**Rezoning Application:** PD 25-0680  
**Zoning Hearing Master Date:** September 15, 2025  
**BOCC Public Hearing Date:** November 12, 2025

Development Services Department

This is a request to rezone from Planned Development (PD) that contains an existing one single-family home on Folio 31294.0000 and contiguous parcels 31296.0000, 31299.000 and 31303.0000 and Residential Single-family Conventional (RSC-9) to a new PD to develop 21 multi-family townhomes and one single-family home.

**PD 95-0276 Site Plan:**

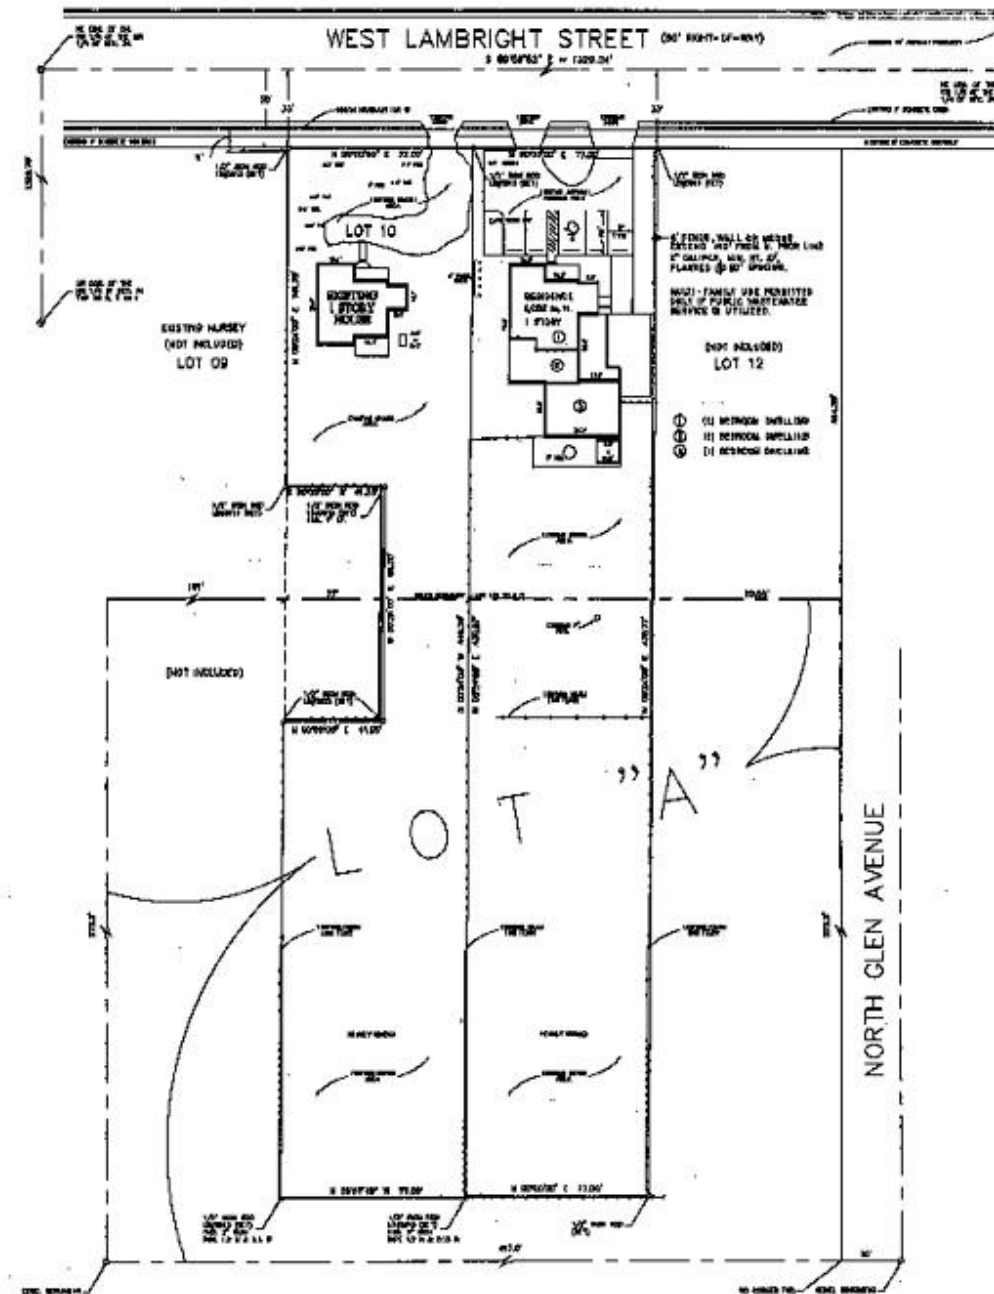
Proposed building height for the multi-family is 35 feet (2-stories). When applying the 2:1 setback requirement, the setback is to be 30 feet in addition to any required buffer. The multi-family building will be located within the southern area of the PD adjacent to single-family residential to the east, multi-family residential to the south and multi-family residential and commercial/office to the west.

Required Setback:	Proposed Setback:
Area of Variance #1:	30 feet	15 feet
Area of Variance #2:	50 feet	40 feet
Area of Variance #3:	50 feet	20 feet
Southern PD Boundary:	30 feet	15 feet

(Variance #1) Properties to the west are multi-family and commercial/office, therefore, no buffering and screening along the west is required per the LDC (Variance #1, which is not applicable). The applicant proposes a 15-foot setback (a reduction of 15 feet from the required 30-foot setback due to the building height).

Properties to the south are developed with multi-family, requiring no buffering and screening. The proposed setback of 15 feet is a reduction of 15 feet from the minimum 30-foot setback (due to building height). The adjacent multi-family units to the south are limited to one-story in height per PD conditions, and a setback of 10 feet from the common boundary.

(Variance #2) Properties to the east are developed with single-family homes, which require a 20-foot-wide buffer with Type B screening in addition to the 30-foot setback (resulting in a total 50-foot building setback). The multi-family building is depicted to have a 40-foot setback and the area adjacent to these homes will be used as the vehicular use area. The 20-foot wide buffer is reduced by 10 feet to provide a 10-foot buffer. Type B screening is proposed. The result is a distance of 40 feet, which consists of a 10-foot buffer and 30-foot setback).

(Variance #3) Where adjacent to folio 31300.0000’s side yard, a 20-foot-wide buffer in addition to the 30-foot setback (resulting in a total 50-foot setback) is required, along with Type B screening. The applicant proposes a 20-foot wide buffer with a 5-foot wide sidewalk encroachment This reduces the buffer/setback by 35 feet. The applicant proposes to provide enhanced Type B screening with trees planting on 10-foot, rather than 20-foot centers.

The maximum density of the proposed project is 25 units (12.9 u/a); however, there is a lack of width and depth at the site to meet the setbacks requirements and buffering and screening requirements, most importantly where adjacent to single-family homes.

Based on the above considerations, staff does not support the proposed project.
